SERVICE TECHNICAL INFORMATION

ONE POINT REPAIR

UTSUNOMIYA, APRIL 30, 1996
REF. NO. : SI-96-006
CUSTOMER RELATIONS & SERVICE DIV.

MODEL : AM - F3
SUBJECT : Improving servo operations when recording
SYMPTOM : Because servo operations during recording are sometimes unstable, when playing the disc after recording, there are cases in which the recording was made in a dropout condition.
REMEDY : In order to improve servo operations, replace the 5 parts listed below.
(Refer to the figure on the next page for the arrangement of parts on the board.)

PARTS LAYOUT

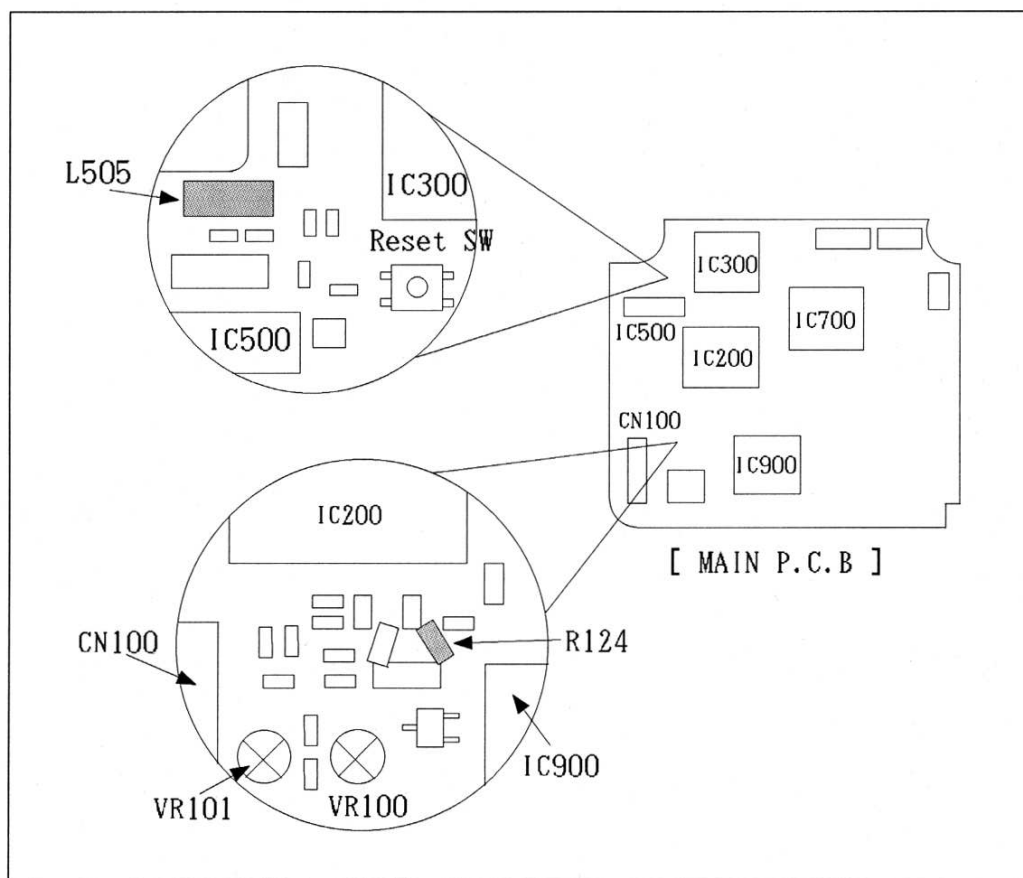
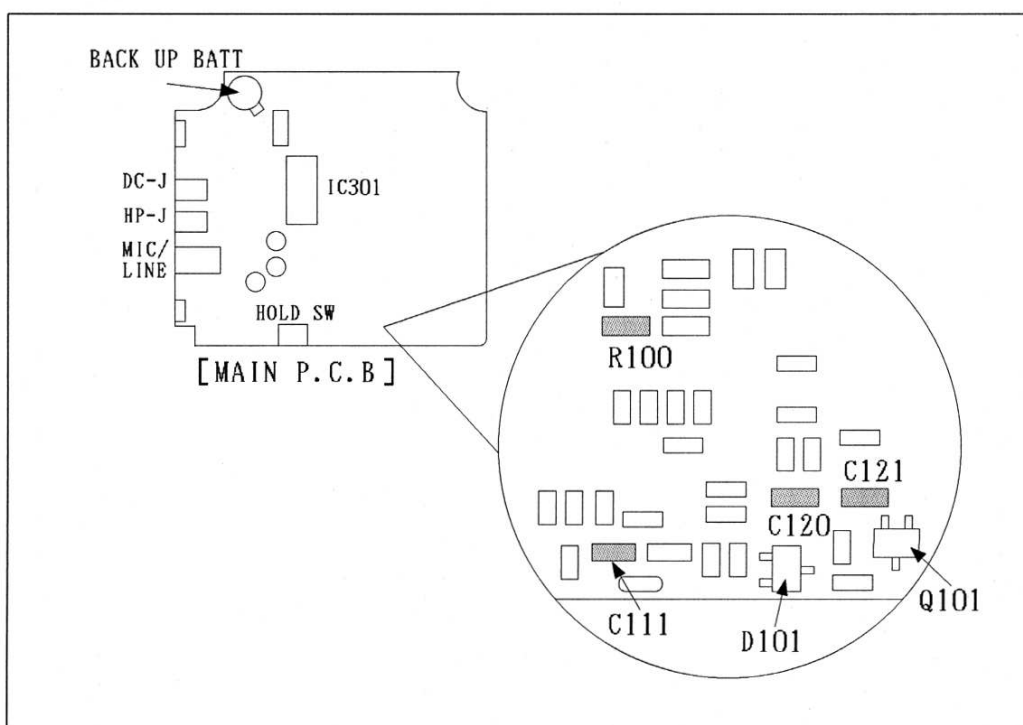
Part No.	Part Name	Contents	Ref. No.
87-A50-108-080	C-COIL 33 μ H	10 μ H \rightarrow 33 μ H	L505
87-010-787-080	C-CAP 0.022 μ F	0.047 μ F \rightarrow 0.022 μ F	C120
87-010-829-080	C-CAP 0.047 μ F	0.1 μ F \rightarrow 0.047 μ F	C121
88-108-183-080	C-RES 470K- 1/16W	680K and 390K Ω \rightarrow 470K Ω	R100
—	—	Remove 18K Ω	R124

Parts position

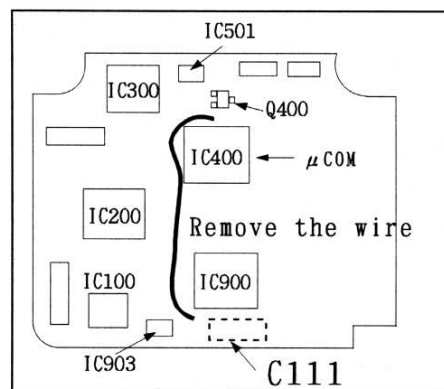
- ① The previous microcomputer and the new type have upper compatibility. However, their circuit configurations are different and so the circuit modification shown below must be performed.

1. Remove one wire from the sets with CXP-81840-115.
(See figure on the right.)
 2. Replace C111 0.1μF with resistor 1KΩ
(C111 is on the bottom side of the board. Check with S/M for the positioning of the parts.)
[Part No.: Resistor 1KΩ 88-108-102-080]

Fiber-Optic Cable Schematic Diagram

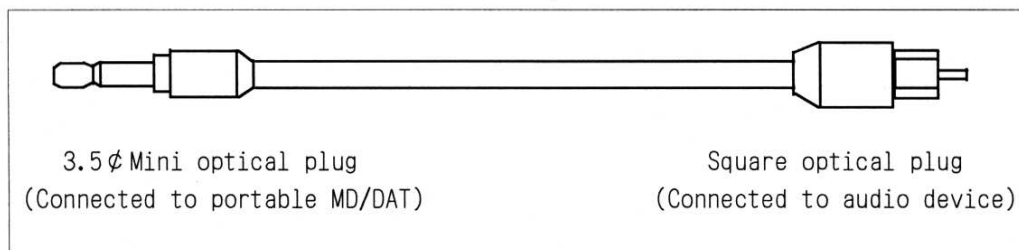
CONTENTS : A 3.5 ϕ pin jack is used as the optical input jack in portable digital devices such as MD and DAT. However, a square optical output jack is generally used in the source-side devices (CD player, audio devices, etc.). Because such fiber-optic cables with both types of jacks are becoming more common on the market, and because many service engineers have told us that it is still difficult to obtain such cables, we will now be providing a fiber-optic cable with a 3.5 ϕ mini plug and a square plug. This cable will be provided as a jig.
